SAFETY RECALL NOTICE

QUICK-RELEASE MECHANISMS

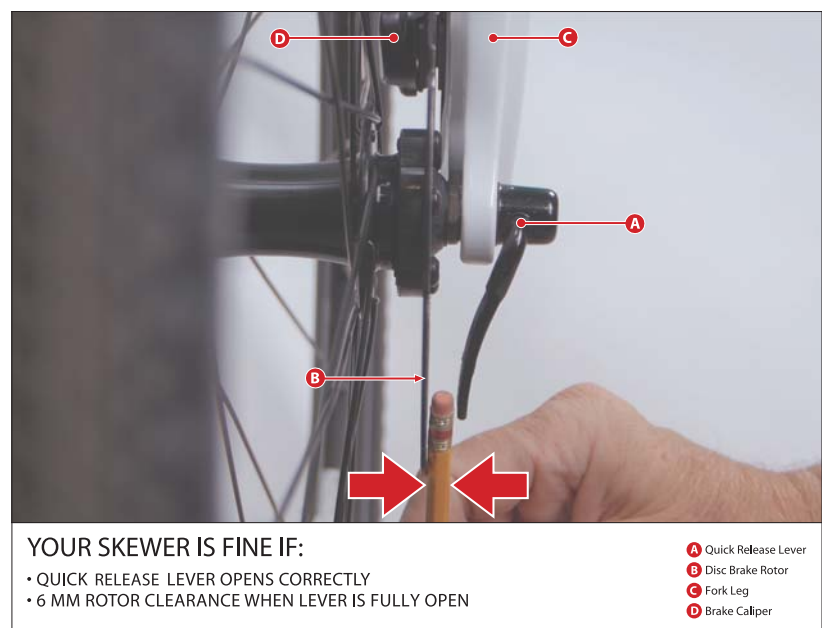
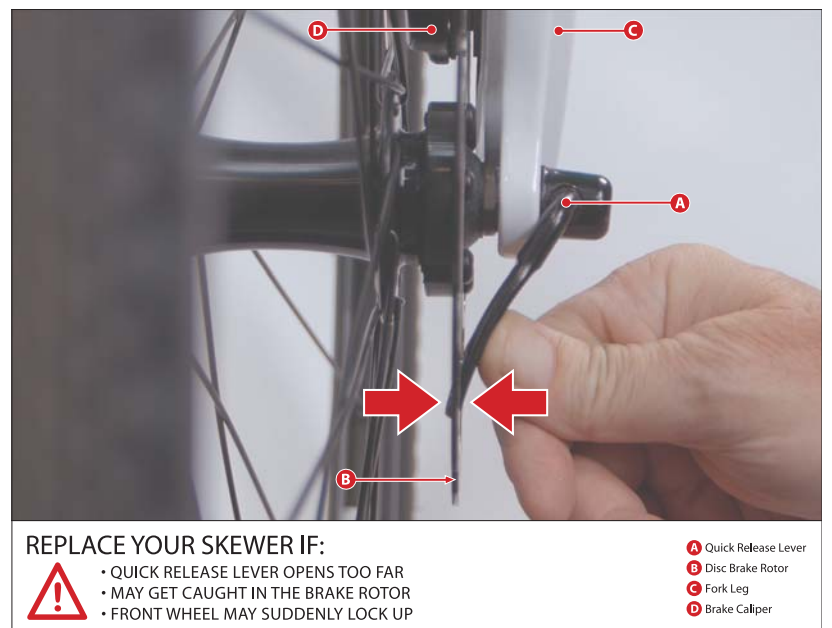
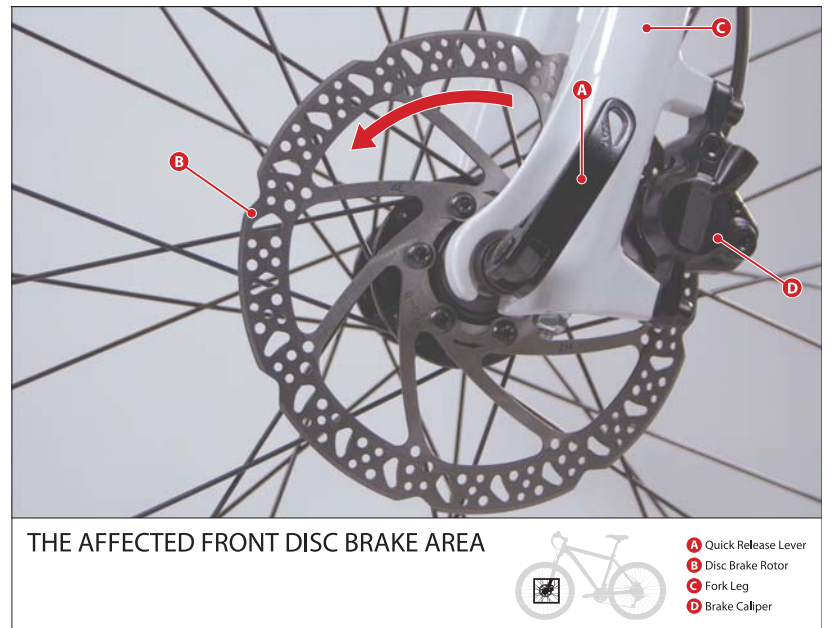
Front-wheel quick-release cam levers that are improperly adjusted or left open during riding and do not meet the #2 Pencil Test below may potentially interfere with the front disc brake rotor, which could result in the rider losing control and sustaining serious personal injuries.

This is a Safety Recall Notice regarding a group of bicycle brands listed below. Only bicycles equipped with front-wheel quick-releases and disc brakes are potentially affected. If the distance between the leading edge of the cam lever in its most open position and the disc rotor is less than 6 millimeters, which is the equivalent of the width of a standard #2 pencil (the “#2 Pencil Test”), your quick-release mechanism needs to be replaced. Please visit www.quickreleaserecall.com for a video demonstration of the #2 Pencil Test.

Stop riding the affected bicycle immediately and bring it to an authorized retailer of your bicycle’s brand, which will replace the affected quick-release free of charge. For any inquiries, please go to www.quickreleaserecall.com, click on the brand of your bicycle, and proceed from there.
